NEDO-32686-A
DRF A74-00004
Class I
October 1998

Utility Resolution Guide for ECCS Suction Strainer Blockage

NRC Bulletin 96-03

Recommendations for Use of NEDO-32686-A "Utility Resolution Guidance for ECCS Suction Strainer Blockage"

Figure B.1. Radial Distribution of the Stagnation Pressure in the Jet.
The actual pressure profile could be different from the linear profile assumed in the ANSI/ANS-58.2 Model.

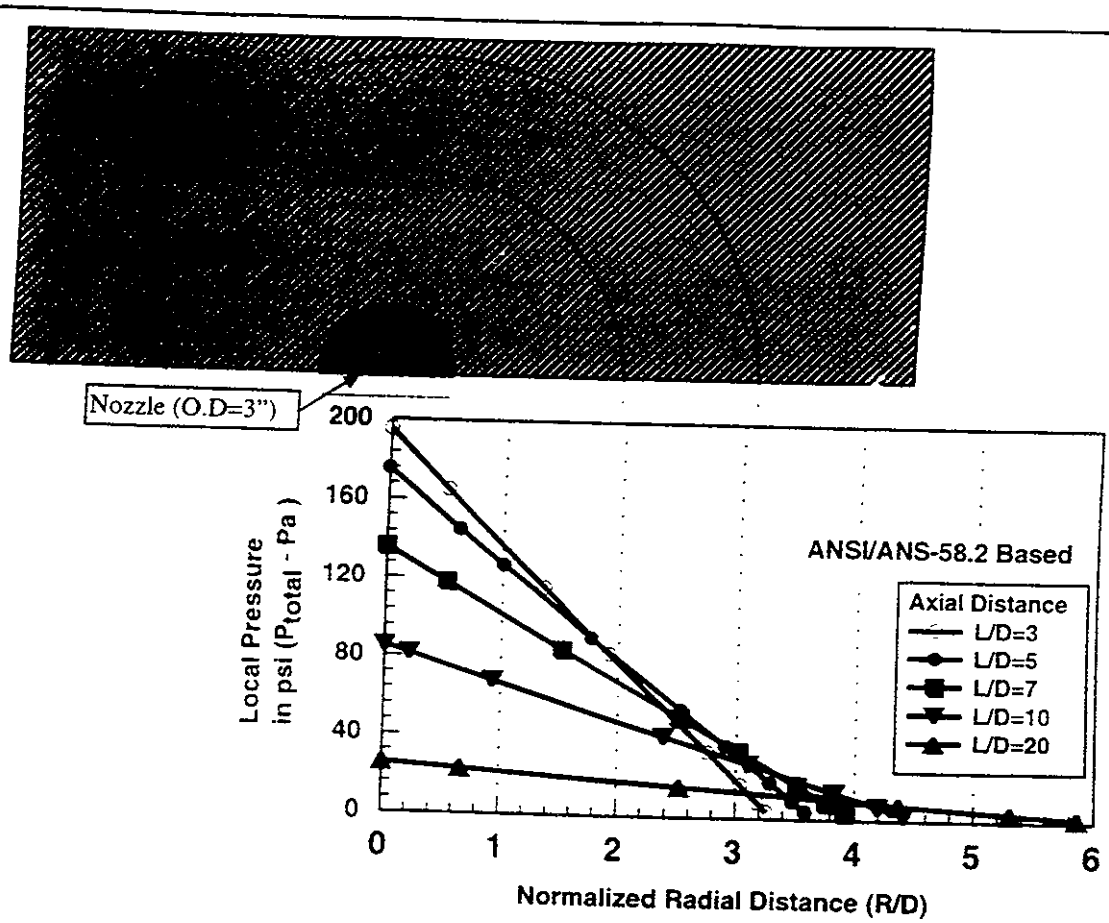
b) The difference in the choice of JCL pressure versus total force can be explained quantitatively by considering the radial distribution of pressures in an expanding jet illustrated in Figure B.1. As evidenced by this figure, at each L/D jet pressures are highest at the jet center-line and decrease rapidly with radial distance (R/D). For analysis purposes, Figure B.1 (of this appendix) uses a linear profile as suggested

by the ANSI/ANS 58.2 Jet Model (Reference B.4) instead of a more realistic profile derived from more CFD calculations (e.g., Figure 11 of Reference B.3). Similar analyses may be conducted using more accurate radial profiles than those used in this study. Nevertheless, the net jet impingement load on the blanket is the sum of multiples of the local stagnation pressure in each radial zone and the area of that radial zone intersecting the blanket. As an alternative, one may choose to relate damage to target area averaged pressure (TAAP), which is essentially the ratio of jet impingement load on the target to the target area. Figure B.2 (of this appendix) compares maximum (or JCL) pressures and TAAPs as a function of axial distance from the nozzle exit plane. A blanket length of 24-inches was assumed to estimate these TAAPs. From Figure B.2, it can be seen that at an L/D of 10, the maximum pressure (or the JCL pressure) is 100 psid versus the TAAP of 40 psid, which is a large difference. For a particular insulation, if the first reported damage occurred at a L/D of 10, the URG shows an estimated damage pressure of 100 psid instead of the more realistic damage pressure of 40 psid.

Figure 1: Plot of head loss versus velocity for fiber and miscellaneous debris and fiber, miscellaneous debris and RMI from gravity head loss testing

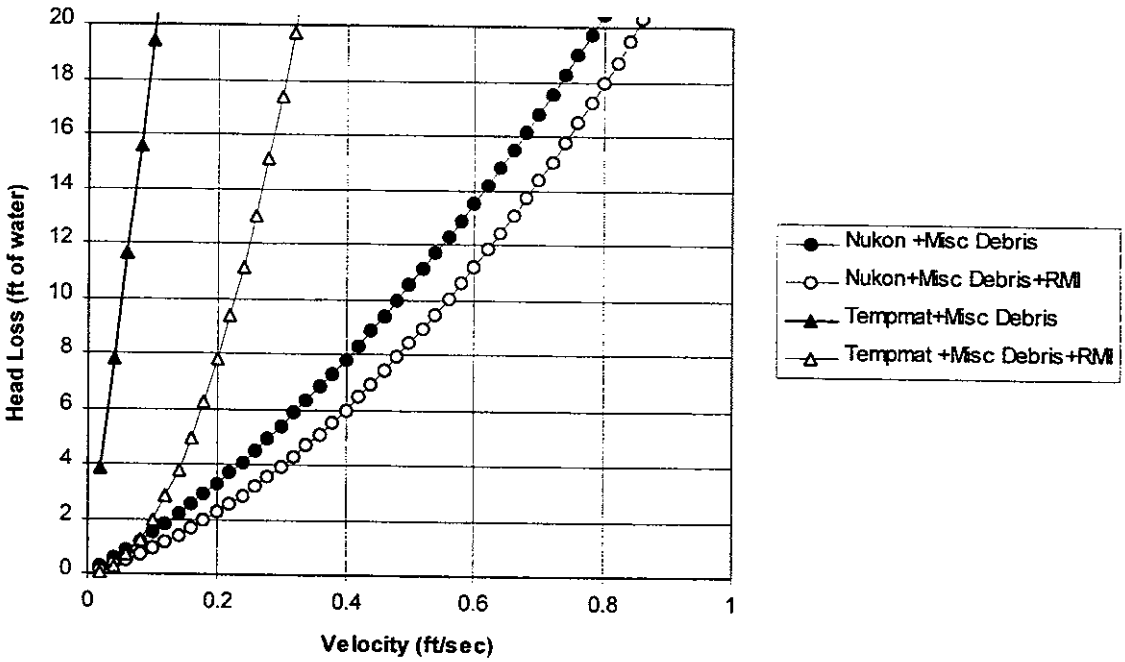
Some gravity head loss testing was conducted with fiber, sludge and miscellaneous debris as reported in URG Technical Support Document Volume 1 Tab 2 Appendix F. Figure 1 plots head loss for Tempmat with sludge, paint chips, rust, sand, cement dust and zinc filler with and without RMI (runs 266 and 269). A similar comparison is made for Nukon base wool (runs 226 and 268) with a different loading of miscellaneous debris and RMI. Both comparisons demonstrate that head loss is reduced when RMI is added to the debris loading.

Finally, consider the results of the Alden Research Laboratory tests documented in test report, "Head Loss of Reflective Metallic Insulation Debris With and Without Fibrous Insulation and Sludge for BWR Suction Strainers", dated May 1996. This report found that with Nukon and RMI debris alone (no particulates) at high approach velocities, the addition of RMI resulted in slightly higher head losses (Reference 2, Figure 7). However, for approach velocities below 0.75 ft/sec there appeared to be no significant difference in head loss when RMI debris was added. Replacement ECCS strainers typically have approach velocities well below 0.5 ft/sec. A more important comparison is with sludge, since all BWR have some level of sludge in their wetwells.

When sludge is combined with fibrous and RMI debris the Alden Research Laboratory results confirm the BWROG position with respect to combined debris head loss. Figures 10 through 15 of Reference 2 compare head loss with and without RMI over a

range of approach velocities. For all velocities of interest, the head loss with RMI is not greater than the head loss without RMI and is usually substantially lower. Test results showed that in general head loss "decreased when RMI debris is present in the mix of fibrous insulation with sludge." Alden plotted the head loss with RMI mixed with fiber insulation and sludge at the various tested velocities against the corresponding values of head loss for fibrous insulation and sludge without RMI (Reference 2, Figure 16). Points above the 45 degree line represent head losses higher with RMI, while points below the line represent lower head loss with RMI. Nearly all the points lie below the line (the biggest exceptions occur at approach velocities of 1.5 ft/sec).

Figure 1 - Overview of Potential Resolution Options

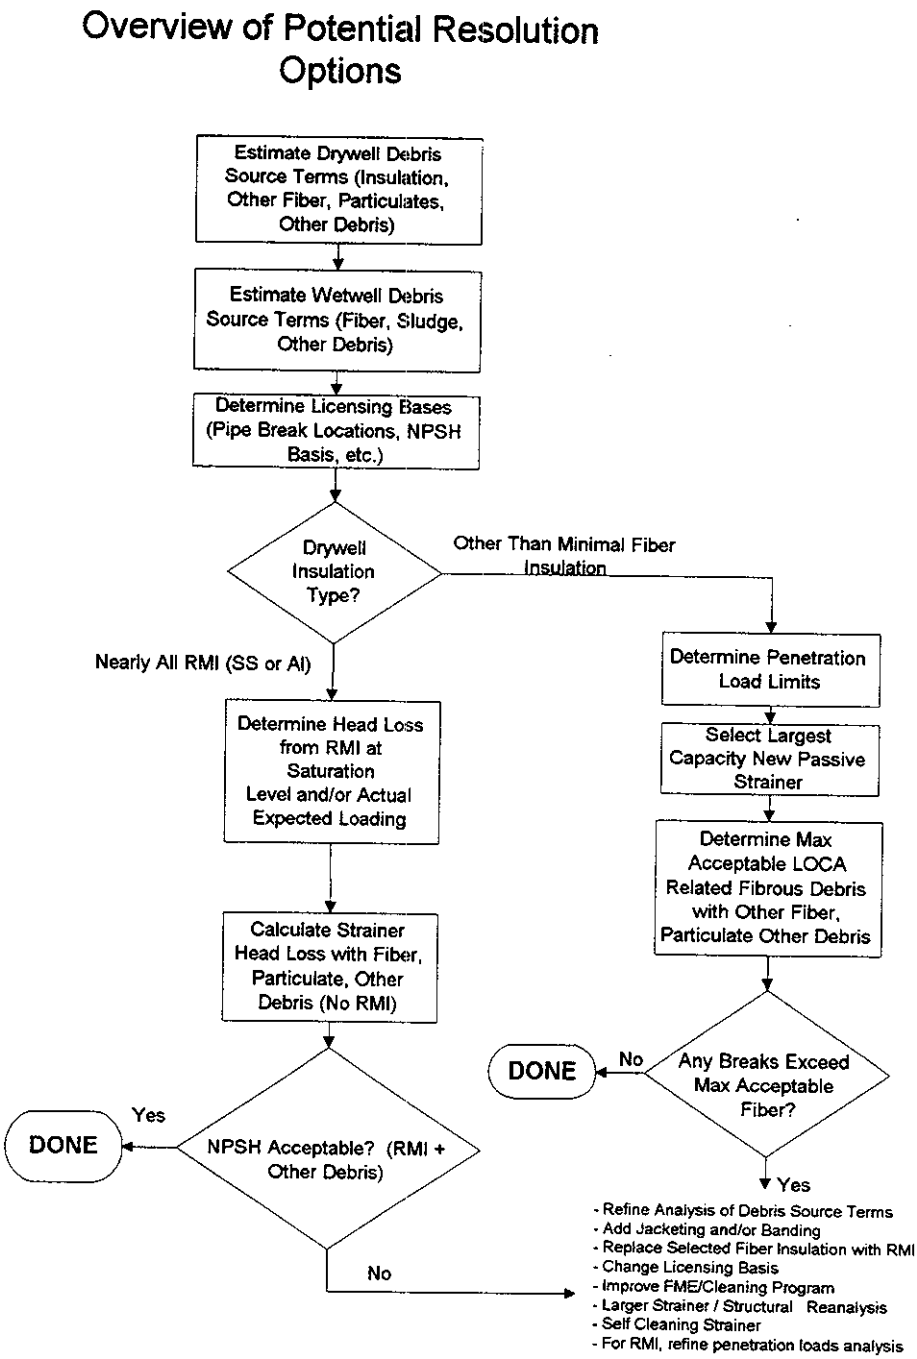
Staff Evaluation for Section 3.1: Figure 1 of the URG provides guidance for plants with a "minimal" amount of fibrous insulation, but does not define what constitutes a minimal amount. In its response (Ref. 64) to the draft SER on the URG (Ref. 63), the BWROG clarified this point. It stated that less than a 0.32 cm (1/8 inch) coverage of the strainer surface by fibrous material is considered minimal. While the staff considers the definition provided by the BWROG to be acceptable, the staff notes that a licensee reviewing Figure 1 is likely in the process of defining the resolution path it intends to follow, and therefore, is unlikely to have performed sufficient analysis to determine if it could potentially entrain "minimal" amounts of fibrous material on its strainer surface during an accident.

Figure 2 - Evaluation Process Diagram - Drywell Debris and Transport

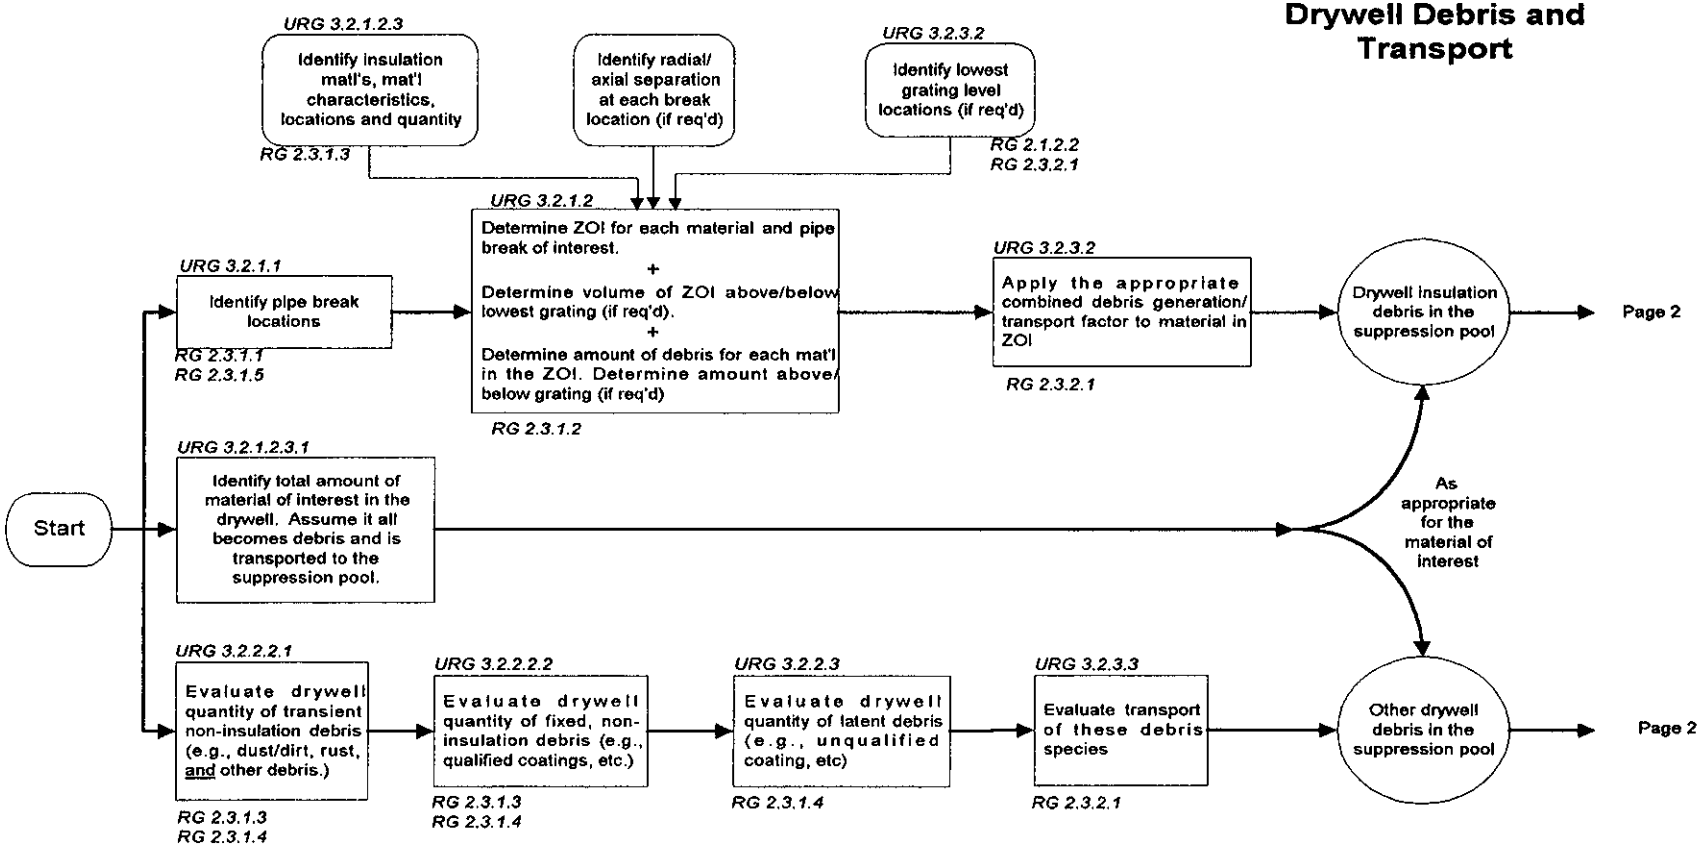
Figure 2 of the URG presents a discrepancy between Section 3.2.1.2.3.1 and the associated step in the flow diagram. The text in the diagram indicates that all of the material of interest in performing a bounding analysis is assumed to be debris which is transported to the suppression pool. This clearly would be the most conservative method for calculating the amount of debris that could be transported to the suppression pool, and would eliminate the need for a detailed analysis. However, the staff notes that the flow diagram for this method cites Section 3.2.1.2.3.1 of the URG, which provides detailed guidance regarding Method 1 for calculating debris generation. The text of this section (page 37 of the URG) indicates that licensees may apply transport factors to the total amount of debris assumed in the drywell. It is not clear which is the intended URG recommendation for Method 1. It appears, however, that two methods are being combined into one. It would be clearer if they were separated. The bounding case would be to assume that all potential debris material in the containment is dislodged and transported to the suppression pool during a LOCA. A second method would be to assume that all of the material is generated as debris, but only a fraction of the total (predicted with the use of a transport factor) reaches the suppression pool. The staff's draft SER on the URG (Ref. 63) indicated that the BWROG should clarify the intent of the URG guidance. In its response (Ref. 64) to the draft SER, the BWROG clarified its intent for Method 1 in Figure 2 stating, "There are really two methods intended, either of which is acceptable. One method is to use a zone of influence that encompasses 100% of the material of interest in the drywell and 100% transport to the suppression pool. The second method is to take 100% of the material of interest in the drywell and then use the transport factors provided in the URG to determine the amount of insulation that reaches the suppression pool." The staff concurs with the BWROG that both of these methods are acceptable.
